UPPER TUMBLING RUN DAM

PHASE I INSPECTION REPORT NATIONAL DAM INSPECTION PROGRAM

UPPER TUMBLING RUN DAM
SCHUYLKILL COUNTY, PENNSYLVANIA
NATIONAL I.D. NO. PA 00689

Name of Dam: Upper Tumbling Run Dam
County Located: Schuylkill County
State Located: Pennsylvania
Stream: Tumbling Run Creek
Coordinates: Latitude 40° 45' Longitude 76° 10'
Date of Inspection: 4 August 1978

SEEPAGE LOCATION PLAN
UPPER TUMBLING RUN DAM

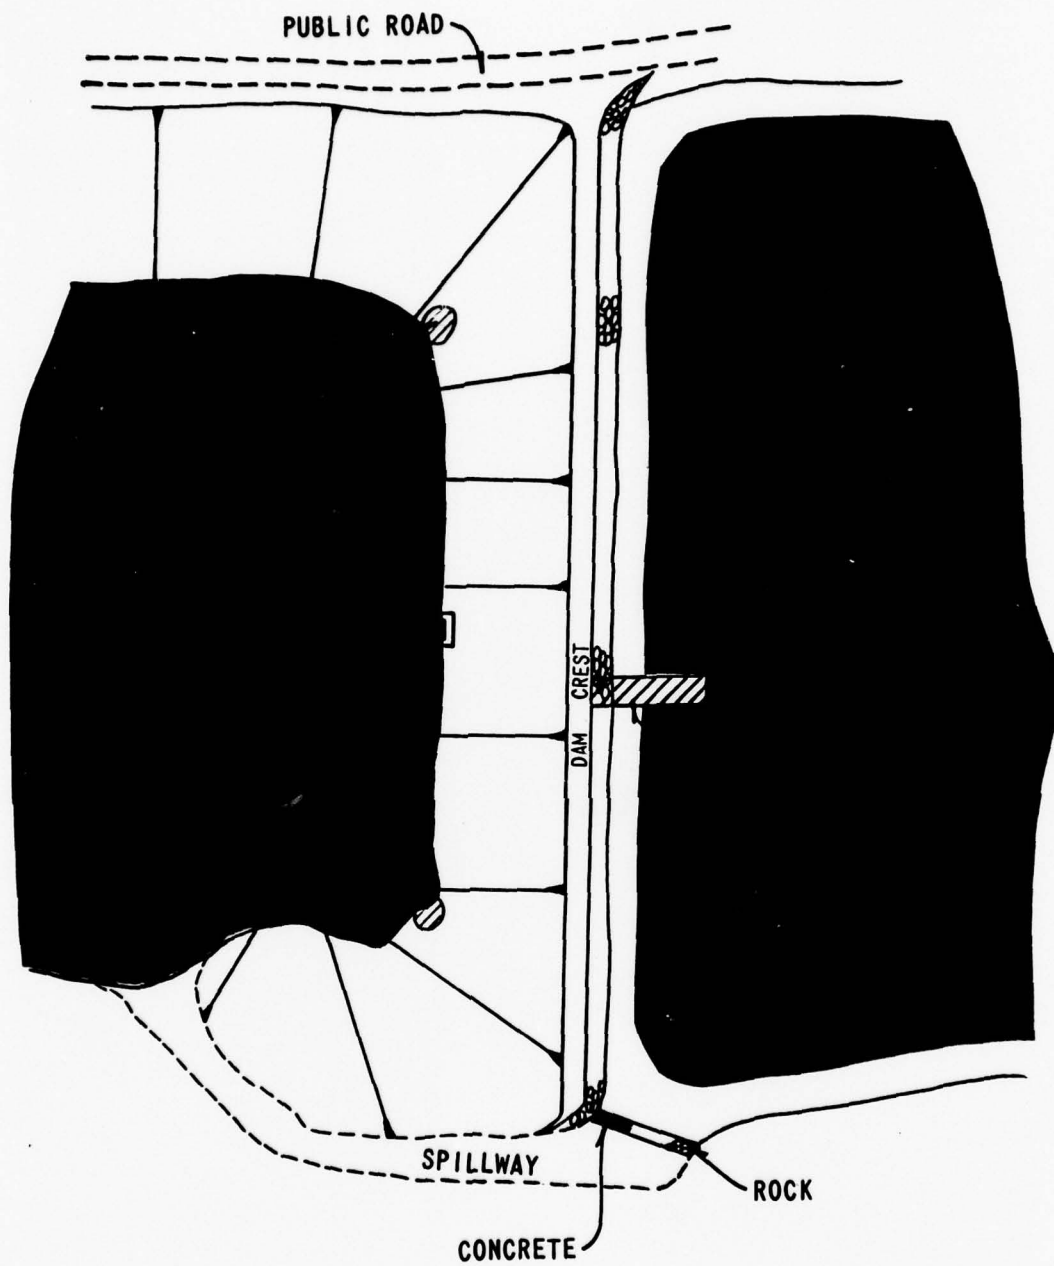
ANY NOTICEABLE SEEPAGE	Yes. Seepage was observed along the left downstream abutment and it was clear. Seepage was also noted at the toe of the right abutment but it could not be traced due to debris and dense vegetation. The Owner's representative stated that beavers deposited this debris.	
------------------------	---	--

1. The underbrush along both abutments should be cleared to facilitate a thorough visual inspection of the seepage sources.
2. Seepage measuring devices should be installed to monitor seepage rates and possible changes in turbidity.

PHOTOGRAPH NO. 4

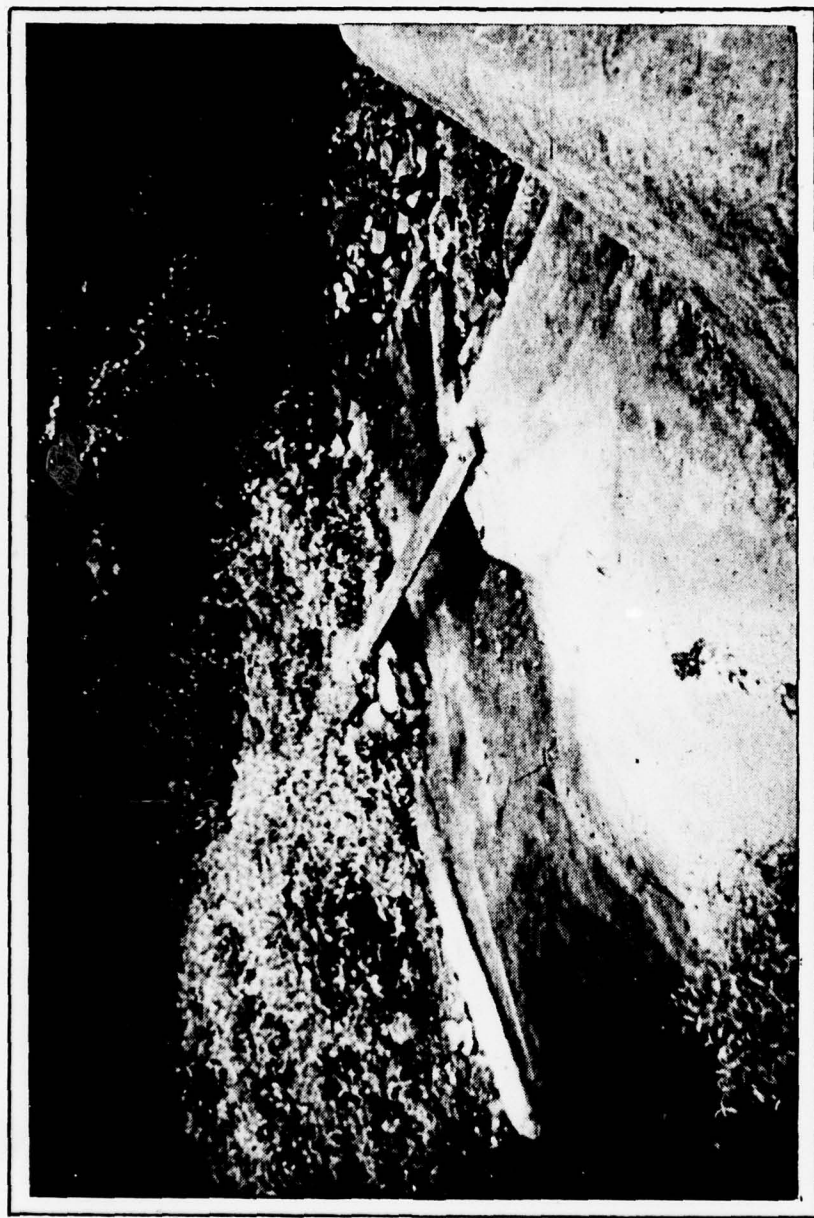
1. Spillway. The spillway was excavated into the rock at the left abutment, and measured to be 52 feet wide at the weir section. The right side of the spillway channel has a mortared stone wall which extends downstream to the point at which the channel is directed into the Lower Tumbling Run Dam reservoir. The left side of the channel has been excavated into rock. Erosion was noted near the change in direction of the channel. The spillway bottom is a very irregular rock surface with some rock spalling noted. Woody vegetation was observed growing in the spillway. See Photographs 4 and 5.

The spillway is in fair condition with stable side channels. The rock surface is very irregular and some spalling was observed. Woody vegetation noted within the spillway should be removed.

PHOTOGRAPH NO. 16

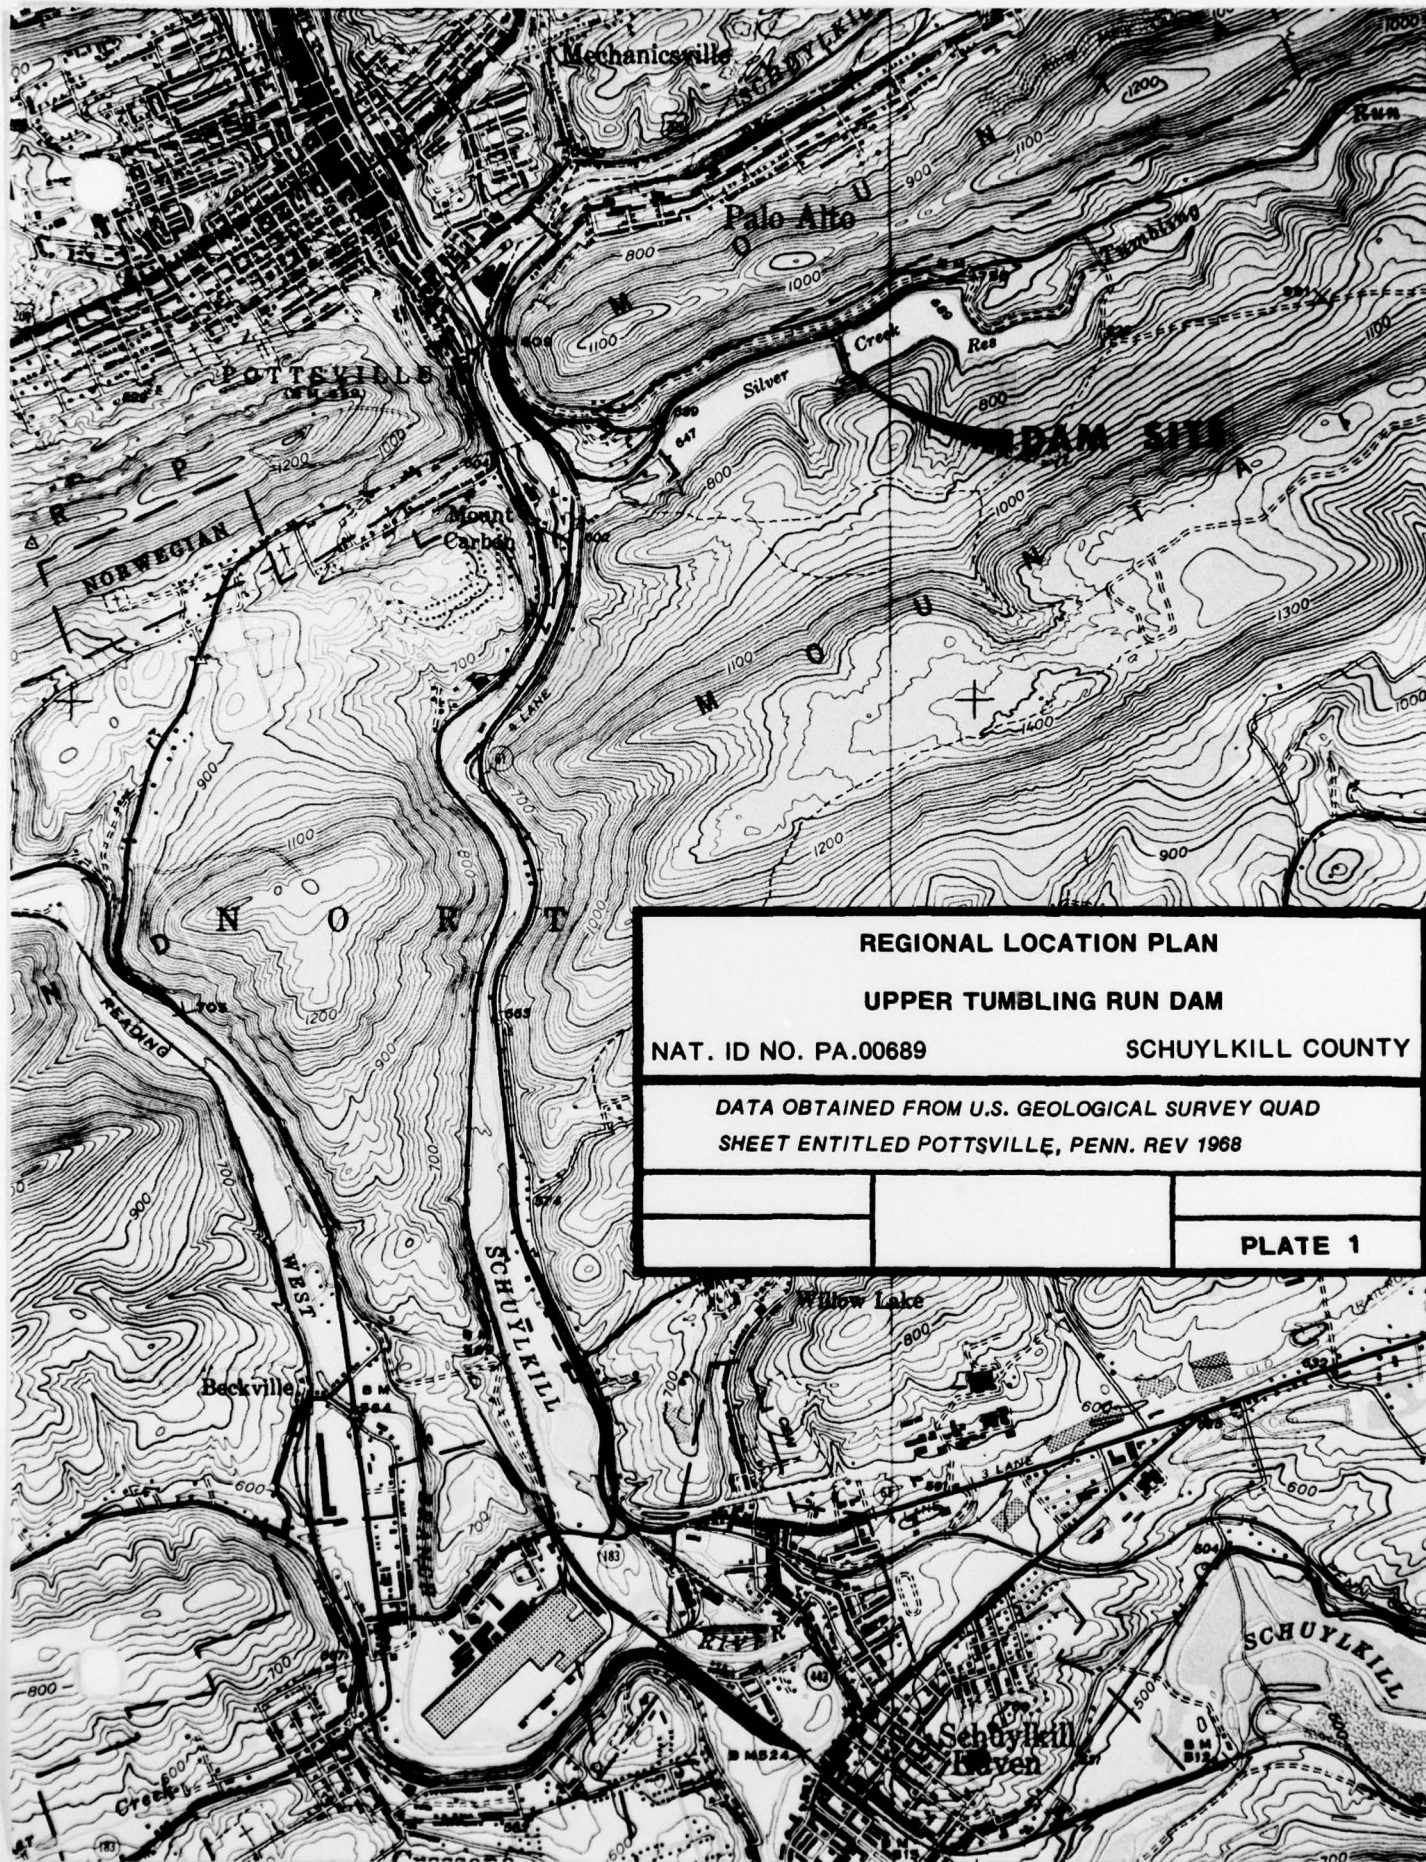
The intake structure is a vertical masonry block wall constructed within the upstream slope, as shown in Photograph No. 15. The discharge structure is also stone masonry with the walls extending approximately 6 feet above the pipes. No changes or modifications to the outlet works have been reported. See Photograph No. 16.

1. The spillway system should be reconstructed to meet current hydrologic/hydraulic criteria.
2. Prepare "As-Built" drawings in conjunction with a geotechnical investigation and stability analyses of the slopes. This should include the installation of piezometers to locate the phreatic surface through the embankment.
3. The outlet works should be inspected and repaired, if necessary.
